## **Appendix D**

### **Construction Program Site Visit Reports**

## **Site Visit No. 1**

### **Thomes Creek Bridge Project Site Visit Date: 10/13/2009**

Photograph 5— Discharge of pollutants from the contractor staging and material storage areas to Thomes Creek

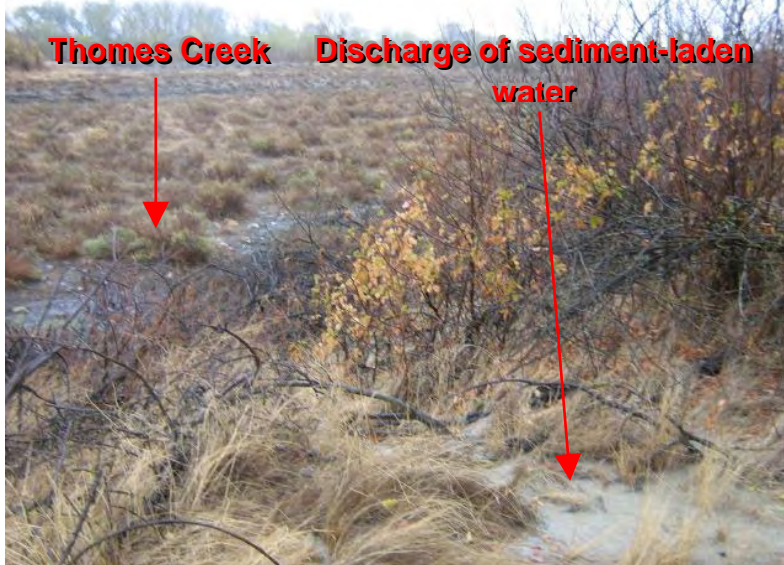
Prohibition A.1 of the Permit states the “discharge of runoff from construction sites containing pollutants which have not been reduced using BAT for toxic pollutants and BCT for conventional pollutants to waters of the United States is prohibited.” Adequate BMPs were not implemented for the contractor’s staging and material storage areas located up-gradient and adjacent to Thomes Creek. Specifically, adequate BMPs or perimeter controls had not been implemented for the areas of disturbance associated with the contractor staging and material storage areas. For example, a concrete washout was improperly implemented and lined with plastic that had been torn and badly deteriorated (see Photographs 1 and 2), and uncontained concrete waste was observed on the ground surface directly adjacent to the concrete washout (see Photograph 3). Jeff Blin (Caltrans District 2, Resident Engineer), explained that the concrete washout area had been present for a long period of time and was not identified in the project SWPPP. Moreover, a visible discharge of sediment and/or other pollutants was observed leading from the contractor staging and material storage areas to Thomes Creek (see Photographs 4 through 7).

Photograph 7—Pipe joint compound located in the eastern sediment basin

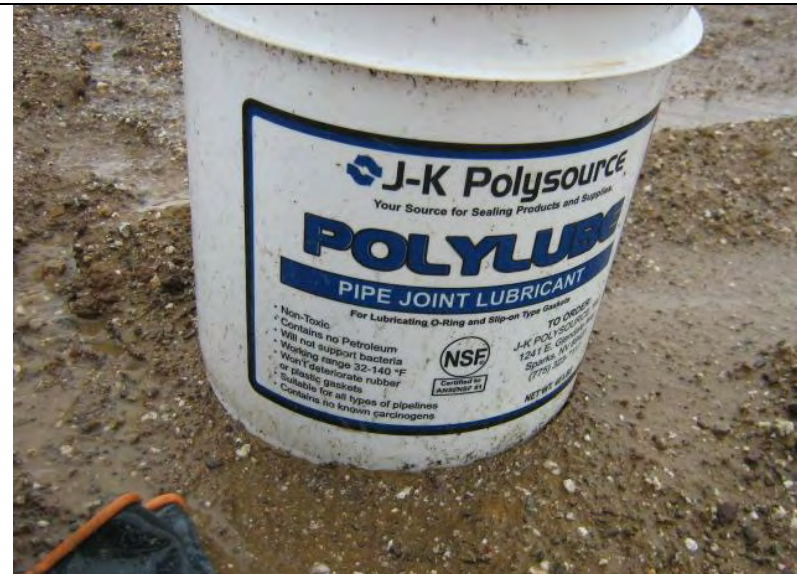
Adequate structural and non-structural BMPs also had not been implemented for material storage. Specifically, full containers of pipe joint compound were observed adjacent to the standing water in the eastern sediment basin (see Photographs 7 and 8). As a result, there was a potential for the contribution of pollutants to storm water runoff.

Photograph 14 – Evidence of the discharge of sediment leading to Birch Creek

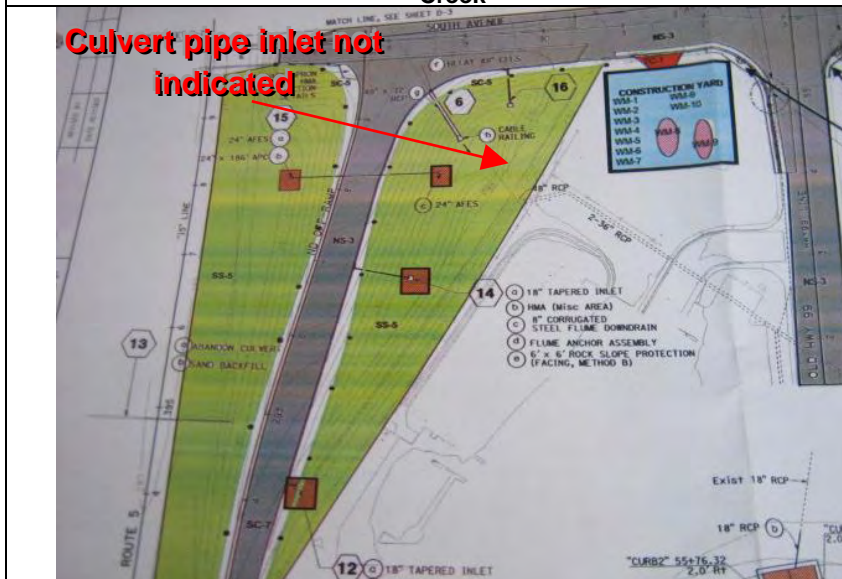
Additionally, inappropriate and inadequate BMPs had been implemented for the interconnected sediment basin discharge point, a culvert pipe inlet and drainage pipe leading to Birch Creek. Specifically, a silt fence BMP had been implemented in an area of concentrated flow at the culvert inlet, and had therefore collapsed (see Photographs 9 through 11). As a result, there was a discharge of sediment from the unstabilized up-gradient areas (e.g., sediment basins and disturbed slope areas) to the culvert pipe inlet and discharge pipe which ultimately flows to Birch Creek (see Photographs 12 through 14).

Photograph 16 – SWPPP site map legend indicated soil binder BMPs and fiber roll BMPs by color.

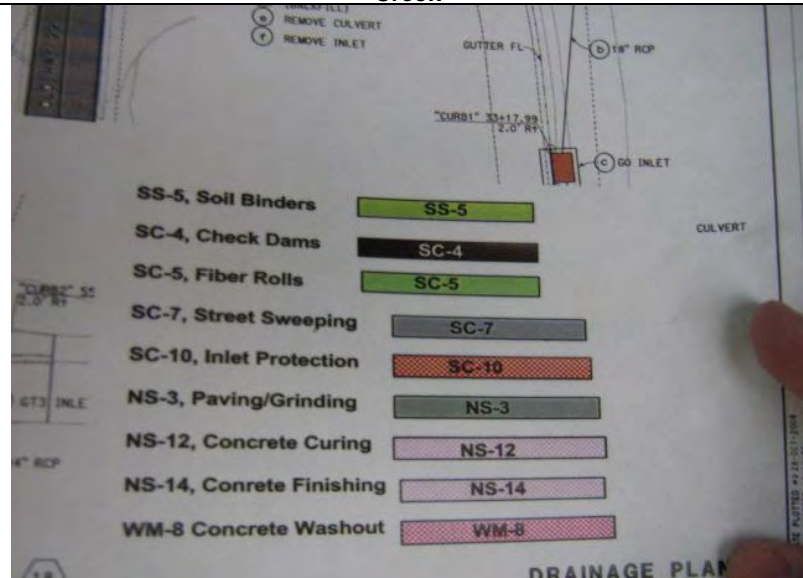
“site inspections and enforcement.” In an oversight inspection conducted on October 6, 2009, the Caltrans Construction Storm Water Coordinator’s inspector indicated that the SWPPP for the South Avenue On-Ramp project was reflective of current site conditions (see Appendix C, Exhibits 4 and 5). The EPA Audit team conducted a brief review of the SWPPP document and site map on October 13, 2009 and noted that the BMPs indicated on the SWPPP site map did not reflect current site conditions. Specifically, the site map indicated that the disturbed slope areas were to have soil binder BMPs and fiber roll BMPs implemented (see Photograph 16); however, these were not observed onsite. In addition, the discharge point, a culvert pipe inlet (see Photograph 9) which drains offsite to Birch Creek, was not indicated on the SWPPP site map (see Photograph 15). Furthermore, as provided by Jim Rodgers (Caltrans Resident Engineer for the South Ave On-Ramp project), the silt fence BMP at the culvert pipe inlet had been approved by Mr. Rodgers; however, there were no SWPPP amendments and the culvert inlet itself was not shown on the SWPPP site map (see Photographs 15 and 16).

Photograph 9—Vantage point photograph depicting location of field constructed sediment basins No. 1 and No. 2 and their outlet.

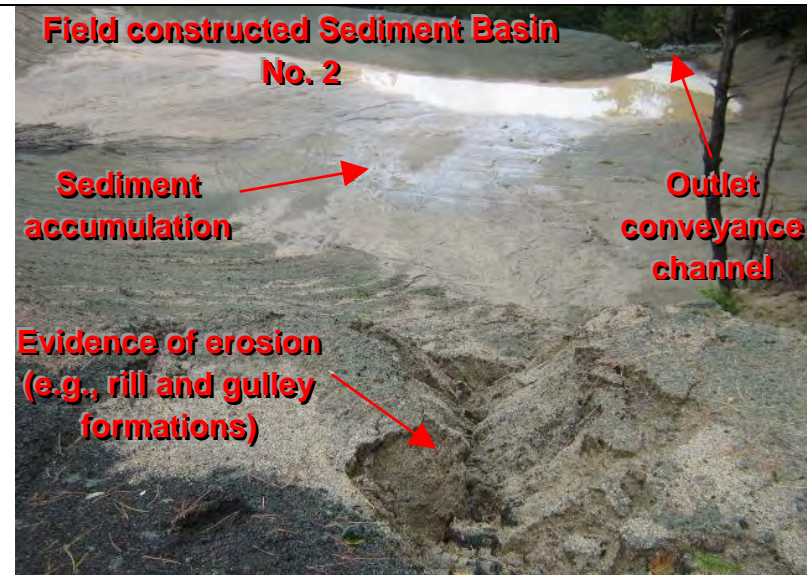
Specifically, adequate BMPs were not implemented to prevent the discharge of sediment from the field constructed sediment basins (see Photograph 9) and from disturbed slope areas adjacent to State Highway 299 (see Photographs 1 and 2). Visible evidence of a runoff event discharging sediment to the field constructed sediment basin No. 2 (see Photographs 2 and 3) and beyond the basin to the unnamed tributary of Crystal Creek (see Photographs 4 through 8) was observed. Visible evidence of a runoff event discharging sediment to the two field constructed sediment basins and sediment accumulation in the basins was observed during the inspection (see Photographs 9 through 12); and within the outlet conveyance channel (see Photographs 4 and 7) which subsequently drains to the unnamed tributary to Crystal Creek (see Photographs 5, 6 and 8).

Photograph 19—Evidence of sediment transport to State Highway 299 drainage swale from the adjacent unstabilized disturbed cut slope area.

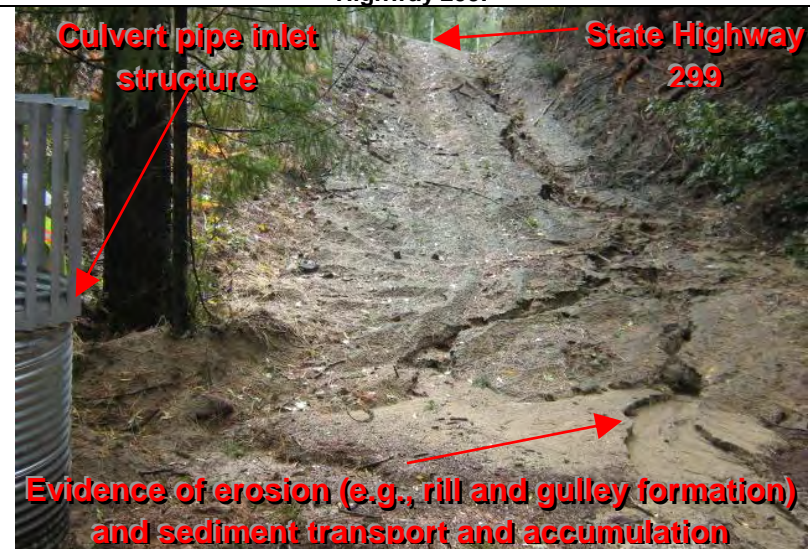
Adequate BMPs were not implemented for disturbed cut slope areas located adjacent to State Highway 299, which ultimately drain offsite via a culvert pipe inlet and drainage pipe leading to unnamed tributary to Crystal Creek. Specifically, adequate structural and non-structural BMPs had not been implemented for the disturbed cut slope areas (see Photograph 18), and evidence of erosion, cut slope failure and sediment transport were observed (see Photographs 18 through 20). As a result, there was evidence of sediment transport from the disturbed cut slope area to the adjacent State Highway 299 drainage swale which drains to the culvert pipe inlet area (see Photograph 20).

Photograph 6 – Close-up of sediment accumulation shown in Photograph 5

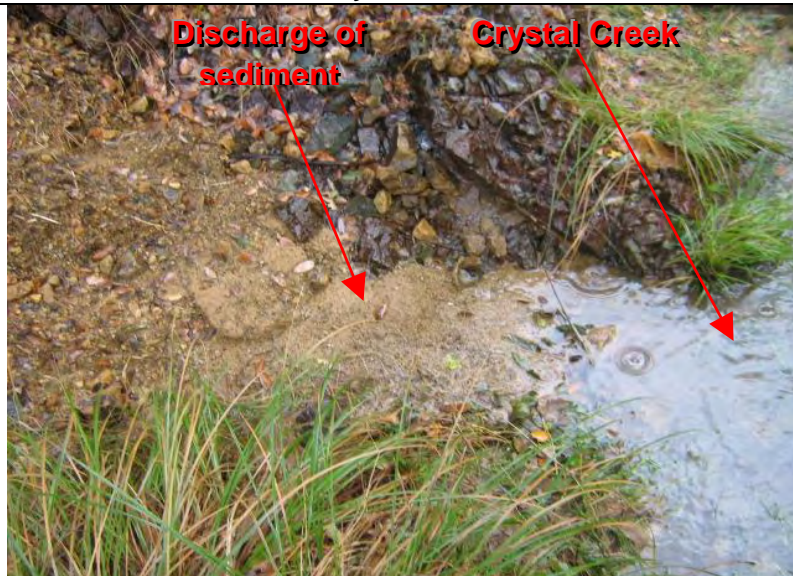
Prohibition A.1 of the Permit states the “discharge of runoff from construction sites containing pollutants which have not been reduced using BAT for toxic pollutants and BCT for conventional pollutants to waters of the United States is prohibited.” Adequate BMPs were not implemented to prevent the discharge of sediment to the adjacent Crystal Creek receiving water located on the south side of State Highway 299. Specifically, adequate BMPs had not been implemented for the disturbed slope areas on the south side of State Highway 299 which subsequently drain to Crystal Creek. Although straw had been blown/spread on the disturbed slope areas, the slope was too steep for this BMP to be effective (see Photographs 1 and 2). There were no run-on control BMPs for the disturbed slope areas and adequate BMPs to break up the slope length had not been implemented. Evidence of erosion (e.g., rill and gully formation, sloughing), slope failure, and sediment transport was observed on the disturbed slope area draining to Crystal Creek south of State Highway 299 (see Photographs 3 and 4). As a result, there was a discharge of sediment from the disturbed slope areas to Crystal Creek (see Photographs 5 through 7).

Photograph 14— Another example of straw wattle not staked or entrenched into ground. Inappropriate application of wattles on impervious surface.

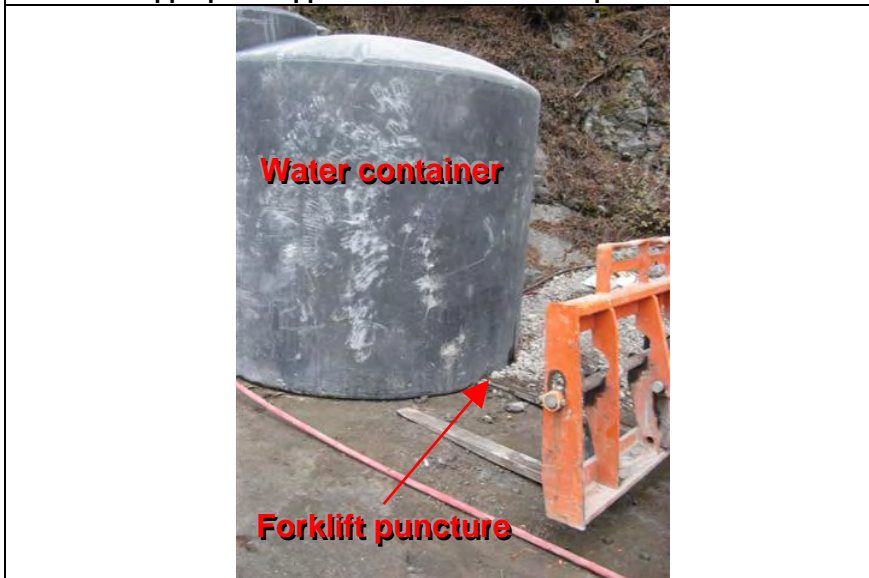
In addition, straw wattle BMPs used for stockpile management were improperly installed on impervious surfaces at the facility, and therefore were not properly entrenched in the ground to retain the stockpiled materials (see Photographs 13 and 14). As a result, there was a potential for the discharge of sediment to the roadway and off-site to the west. The Resident Engineer explained that the SWPPP had been amended to include the use of straw wattle BMPs on impervious surfaces; however, this was not confirmed by the EPA Audit Team.

Photograph 16— Close-up view of puncture in water container

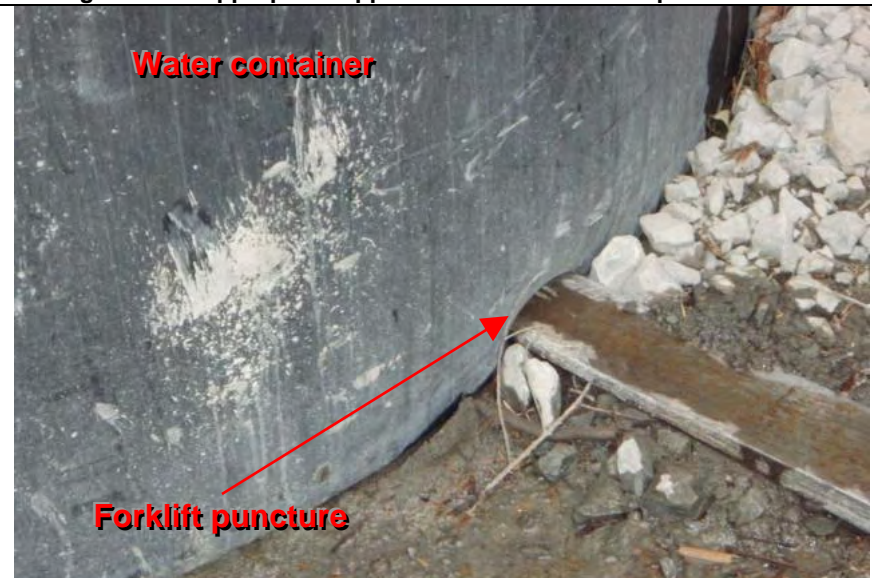
The EPA Audit Team observed that a water storage tank (approximately 1,000-gallon capacity) located up-gradient had been punctured by a forklift and was leaking (see Photographs 15 and 16). Water was observed slowly flowing underneath the straw wattle BMPs that been placed on the impervious roadway surface adjacent to K-rail barriers near the southern end of the construction project (see Photograph 17). The straw wattle BMPs had been installed prior to the puncture incident. Water had flowed underneath the straw wattles and jersey barriers and was observed on the adjacent roadway (see Photograph 18).
